ASSESSMENT REPORT

Rockley Falls Quarry - Modification Wet-Mix Batch Plant and Extended Operating Hours (07_0078 MOD 5)

Figure 2: Proposed Wet-Mix Batch Plant Location

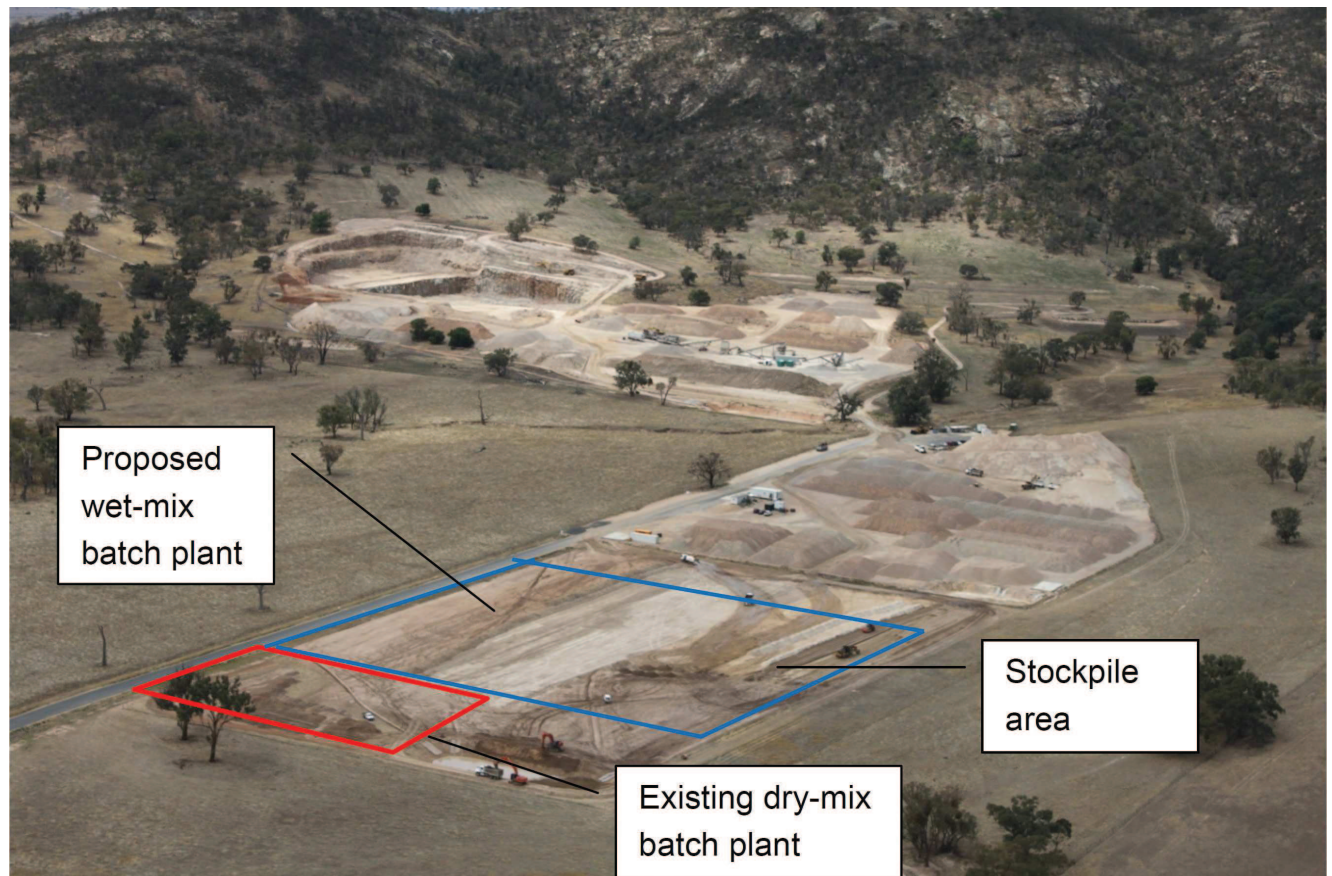
On 2 February 2011, Abigroup asked the Minister to modify the project approval for the Rockley Falls Quarry under section 75W of the *Environmental Planning and Assessment Act 1979* (EP&A Act). Abigroup proposes to establish a temporary wet-mix concrete batch plant within the existing aggregate stockpile area for the site (see Figure 2), adjacent to the existing approved dry-mix batch plant. Following a 30 day commissioning period, the wet-mix batch plant would be used for approximately 90 days to supply 21,000 m³ of concrete for the construction of a section of the Hume Highway Duplication Project.

Abigroup also proposes to extend operation of the quarry and batch plant for an hour each side of the approved operating hours (ie 6am to 7pm) Monday to Friday. This extension would apply during the operation of the wet-mix batch plant to enable the delivery of concrete to the highway upgrade site by 7am.
